Re-application  
1 - 2 THE HERMITAGE, RICHMOND, TW10 6SH

## Heritage and Planning Statement

### 1 - 2 THE HERMITAGE, RICHMOND, TW10 6SH

This statement is in support of a revised planning application.

Side elevations compared L to R: existing; and now proposed

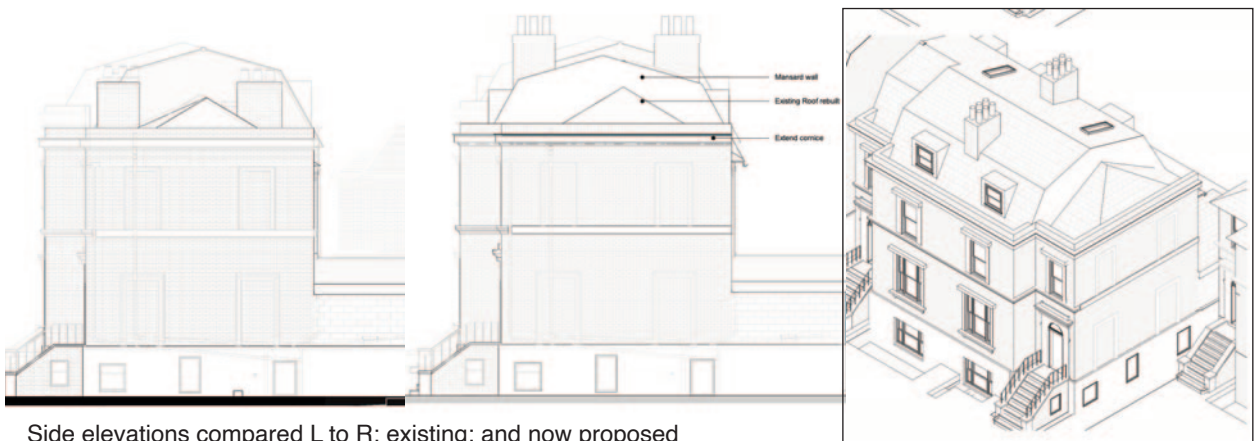
- Proposals seek to construct a mansard-style roof extension with front and rear dormers to match the extensions at nos. 3 - 10. This would involve the complete removal of the existing, original roof form.

- Although it is acknowledged that similar roof extensions are present at four of the six pairs in the group, these were all implemented in the late 20th century (with no planning history for nos. 6-10), and therefore significantly pre-date current planning policies and guidance.

- As noted above, these form bulky additions to the roofscape and have completely obscured the original roof forms, having a harmful impact on both the appearance of the buildings and the architectural integrity and cohesiveness of the wider group.

- The proposed roof extension would result in the complete loss of the original roof form, which is unacceptable. This total loss of both original historic form and fabric would have a harmful impact on both the architectural integrity, character, and significance of the pair as BTMs.

- The roof extension would be a dominant and bulky addition to the top of the pair, with a substantial addition of mass at roof level. The negative visual impacts of such extensions are clear across the wider group, where the roof extensions are visible from side views as large additions to the roofscape. The proposed extension would be a dominant addition to the pair and would fail to be sympathetic or subservient to the main building.”

In my view, the constant repetition of the same, tautological, point, namely that a roof extension obscures the original roof form, underlines the weakness of the objection. That the original roof form is not visible from the surrounding street is not pointed out. My photo on page 1 demonstrates the invisibility of the existing, original roofs of Nos. 1 and 2 from the street. These are not listed buildings so the loss of ‘original fabric’ is not relevant. >>>

>>> The report notes the significance of the group as Buildings of Townscape Merit, and that the absence of the roof extensions makes these houses inconsistent with the group. In my view this reduces the group quality. Nos 1 and 2, being the end pair at the bottom of the hill means that the proposed roof extensions, whilst looking similar to the others from the front, will be more visible from the exposed side view. This revised application acknowledges the unusual prominence of the end elevation by reducing the bulk and form of the roof extension while still achieving the matching frontage appearance. This will serve to reinforce the similarity of this pair to the adjacent houses in the group. Please see the drawing extracts for comparison.

The pre-application design omitted the heavy cornice which extends from the front and along the blind side elevation. This omission emphasised the visibility of the roof extension and was rectified in the previous application. The form of the roof extension has now been further diminished to minimise its visual impact given the special visibility at the end of the group and the falling away of the street.

The pre-application report also criticised the glazed nature of the proposed rear dormers, and said they would fail to retain a satisfactory window hierarchy as they would be significantly larger than those in the floors below. This too has been addressed in the revised proposal. Please see the 3-D view above and refer to the Design and Access Statement.
